APPENDIX V

ORANGE COUNTY HYDROLOGY MANUAL ADDENDUM NO. 1

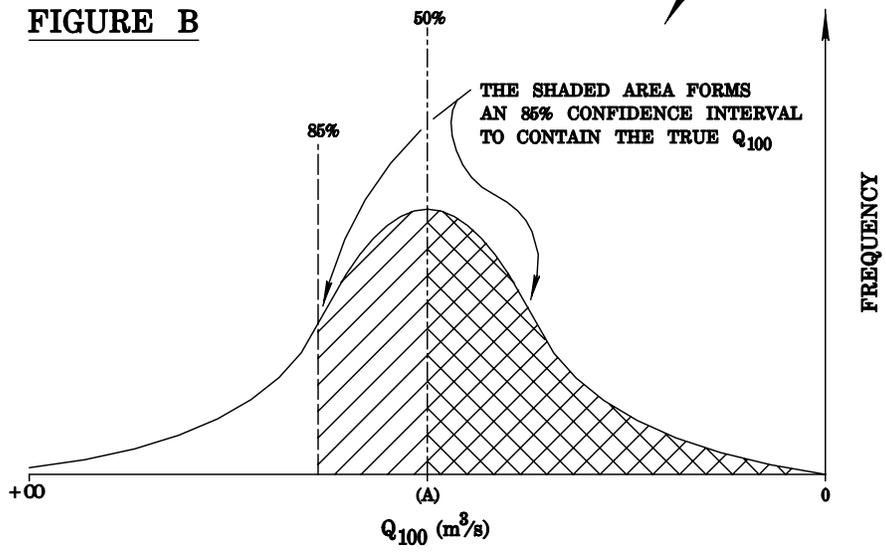
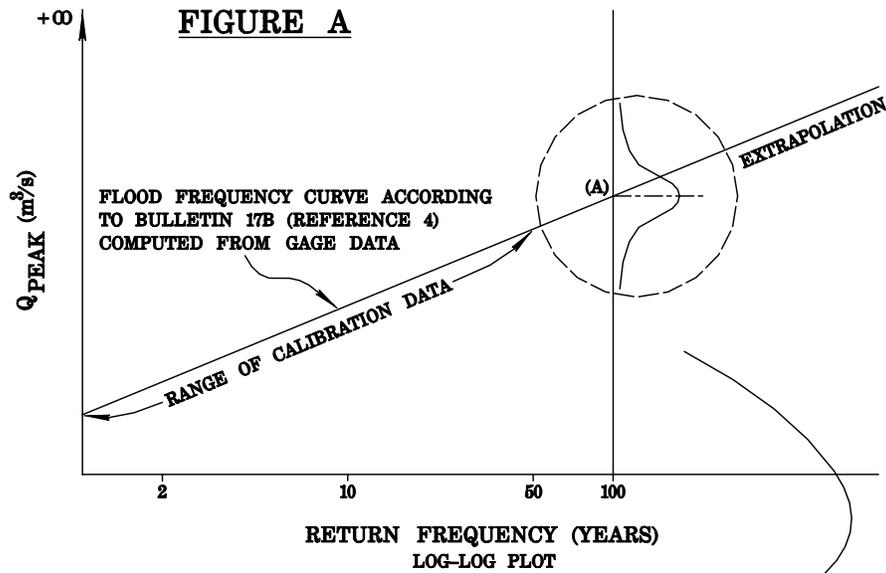
The criteria and methods used in the 1986 Orange County Hydrology Manual (hereinafter "Manual") yield high confidence (85% confidence interval) peak discharges and volumes that are appropriate for most flood control design purposes. The Manual parameters were originally based on a regional calibration study that was subsequently expanded by the U.S. Army Corps of Engineers in "Derivation of a Rainfall-Runoff Model to Compute N-Year Floods for Orange County Watersheds", November, 1987¹ and by Williamson and Schmid in "Determination of 500-Year Floodplain, Confluence of San Diego Creek and Sand Canyon Wash", March 12, 1991². There are special circumstances where such high confidence discharges may not be appropriate. This addendum establishes criteria for the use of expected value (50% confidence interval) peak discharges for design under such circumstances. Figures A and B show the definition sketches for 85% and 50% confidence intervals.
